## Doc 15: 10 Back Lane Rear Elevation with Numbered Windows

**From:** Harriet McCartney <[Harriet.McCartney@ribblevalley.gov.uk](mailto:Harriet.McCartney@ribblevalley.gov.uk)>  
**Date:** 1 October 2019 at 14:00:59 BST  
**To:** erika eden-porter <[erikaedenporter@yahoo.co.uk](mailto:erikaedenporter@yahoo.co.uk)>  
**Subject:** RE: 8 Back Lane Amended Plans

**Rear Elevation**

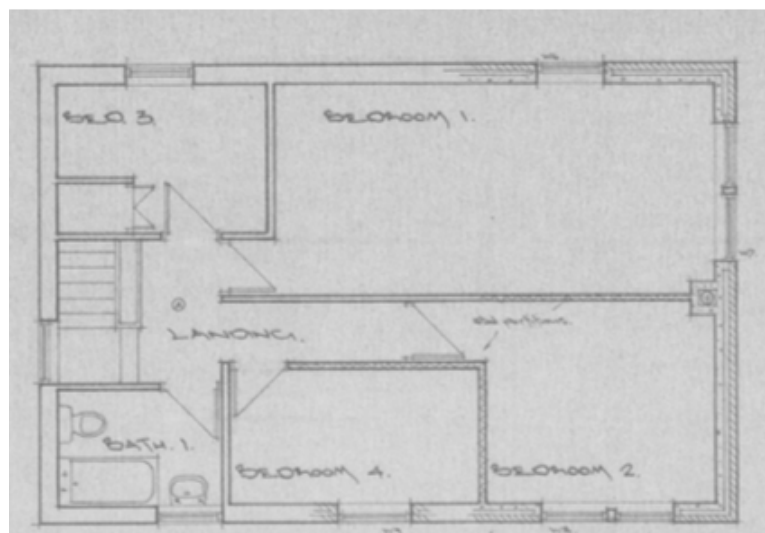
With regards to the rear, the proposal will result in a significant loss of light to the first floor bedroom at the rear, the window to which lies just off centre to the elevation, and as such is not considered to be acceptable.

Due to the orientation of the application property and based on the level of information I have received in terms of plans, the proposed extension will result in an unacceptable loss of light to a first floor rear bedroom. In order to result in no loss of light the first floor element could only project approximately 1m from the existing rear elevation.

- The proposed front extension exacerbates the existing poor relationship with the neighbour to the north.
- A loss of day light, sunlight and resultant shadowing to the first floor windows as well as the kitchen bellow (which is not a habitable room) and the rear garden amenity space
- Possible overbearing impact on both the host property and the neighbouring dwelling.
